RE: Gold Hill Mill, Permit No. M-1994-117, Amendment Application (Revision No. AM-01), Adequacy Review No. 5

This is the Colorado Milling Company, LLC's Response Letter to the items listed in Amy Eschberger's July 23, 2019 Adequacy Review No. 5 of the Application for an Amendment to the Gold Hill Mill Limited Impact 110 (2) Permit No. M-1994-117, to formally add the previously permitted Left Hand Creek Pump Station, Gold Hill Mill Pipeline, and the Times Mine adit portal to the affected land boundary of the Gold Hill Mill Permit. These three features are collectively referred to as the Gold Hill Mill Waterline in this Response Letter. In order to ensure that the responses to the Division of Reclamation, Mining and Safety's request for additional information and clarification can be properly reviewed, the responses are set out below each of Amy Eschberger's Adequacy Review comments.

E-1A MINING PLAN MAP FOR PERMIT AREA NEAR LEFT HAND CREEK
COLORADO MILLING CO. LLC.-GOLD HILL MILL WATERLINE
LOCATED IN SE/4 SECTION 2, T-1-N, R-72-W OF THE SIXTH P.M., COUNTY OF BOULDER, STATE OF COLORADO

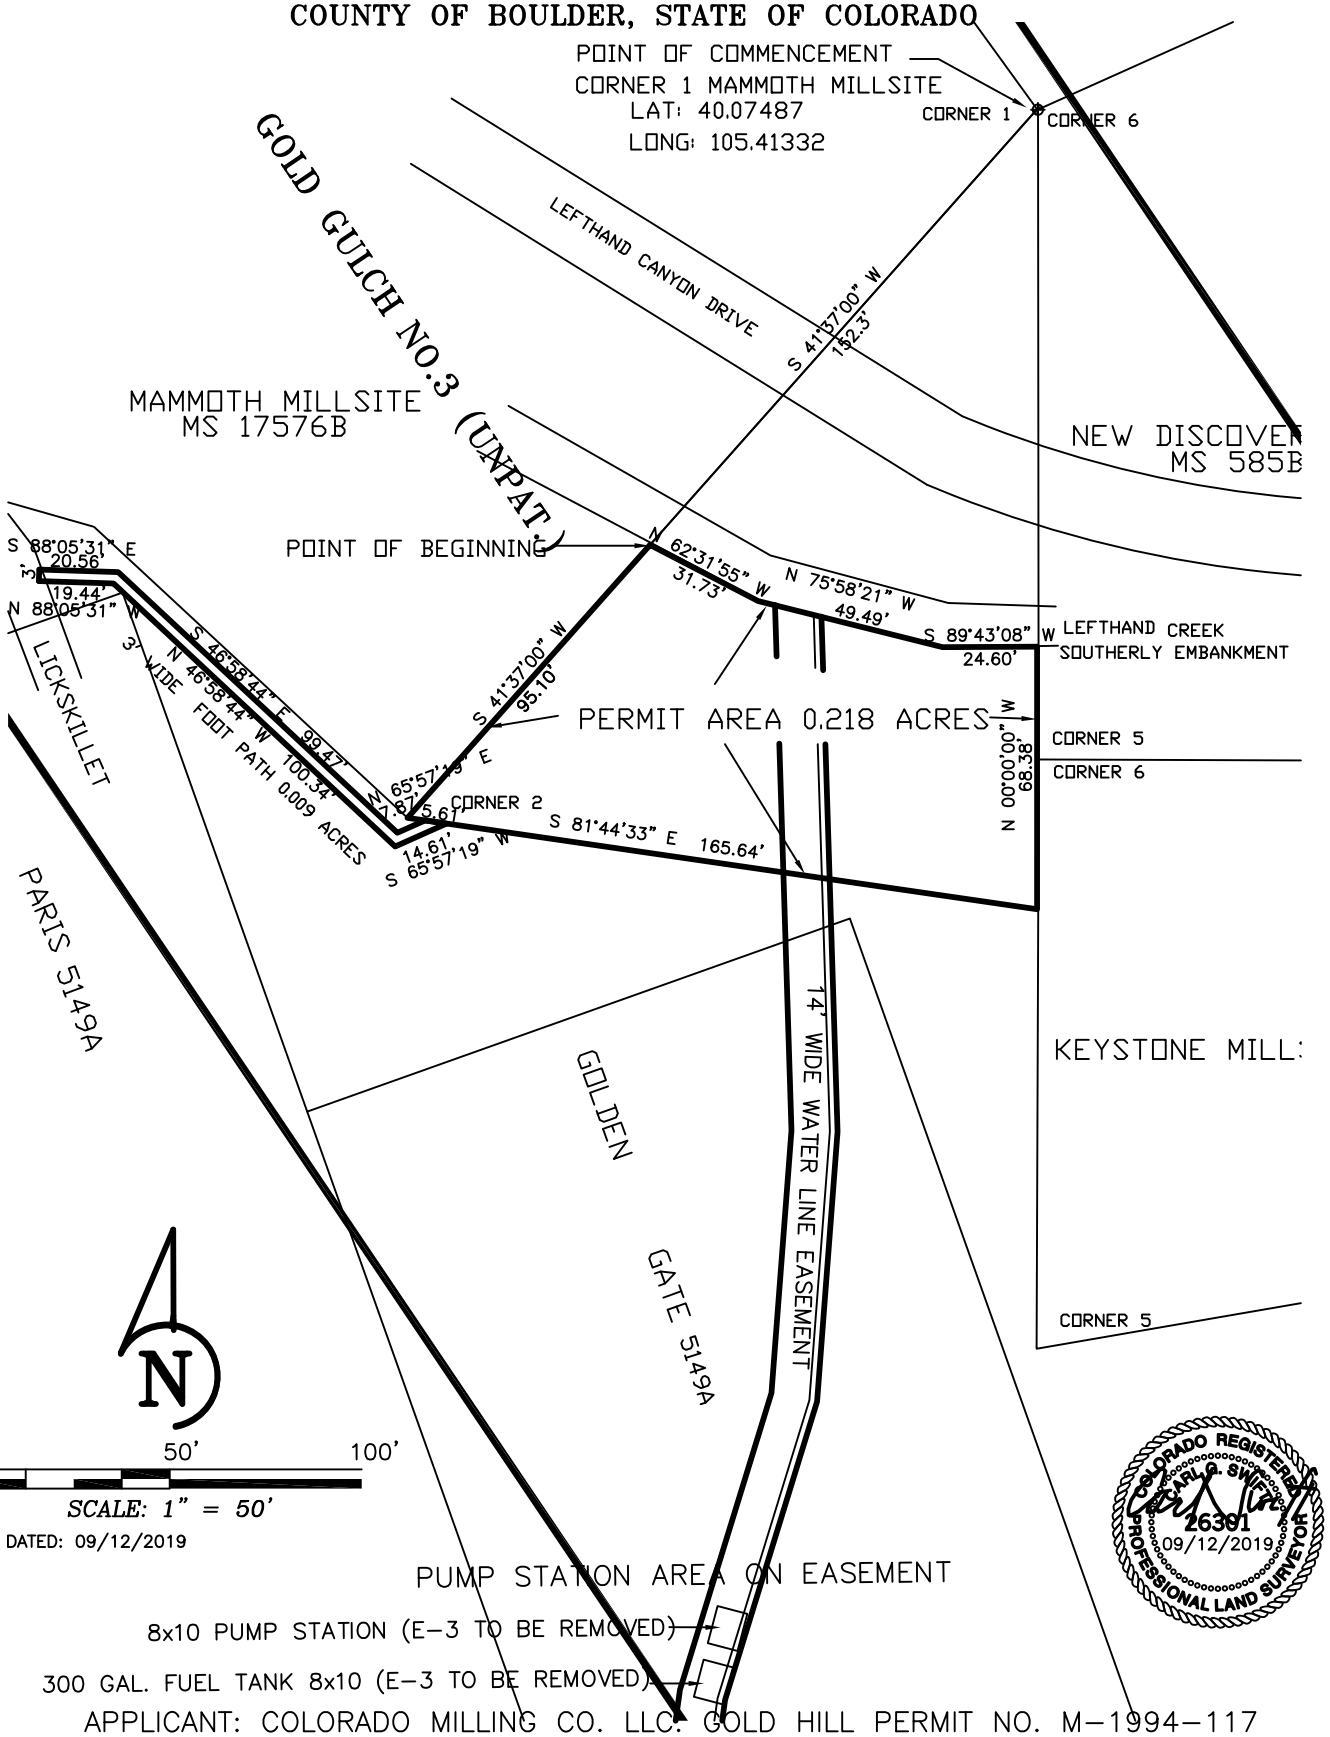
8) Please submit a revised Figure E-1 which conforms to the following criteria required by Rule 6.2.1(2):

a. Show name of Applicant.

b. Must be prepared and signed by a registered land surveyor, professional engineer, or other qualified person.

c. Give date prepared.

d. Identify and outline the proposed permit boundary, as also required by Rule 6.3.5(2)(a). The revised map does not adequately identify the proposed permit boundary. Two potential methods for properly identifying the permit boundary include using a unique outline and an appropriate legend to describe what the outline represents, or using arrows and text to indicate the location of the permit boundary. Please be sure all portions of the permit boundary shown on the map are identified (pump station area and waterline area).

e. Include an appropriate map title. The revised map is titled "E-1A Permit Area", which does not appropriately indicate the type of map. The Division suggests revising the title to "E-1A Mining Plan Map for Permit Area near Left Hand Creek", or at a minimum "E-1A Mining Plan Map".

CMC Response: The name of the Applicant is shown on the bottom of the map.

CMC Response: This map was prepared and signed by Carl G. Swift, Colorado Registered Professional Land Surveyor No. 26391, doing business as: Mountain Surveying, LLC., P.O. Box 783, Nederland, Colorado 80466.

CMC Response: This map was prepared on September 12, 2019.

CMC Response: The proposed permit boundary has a unique, bold outline and an appropriate legend to describe what the outline represents, and arrows and a text have been added to the map to indicate the location of the permit boundary. All portions of the permit boundary in this area near Left Hand Creek have been identified, including the location of the Left Hand Creek Pump Station the Water Line Easement.

CMC Response: The map has been titled **E-1A MINING PLAN MAP FOR PERMIT AREA NEAR LEFT HAND CREEK.** It is attached to this Response Letter along with a Legal Description of the Permit Parcel for this area near Left Hand Creek.
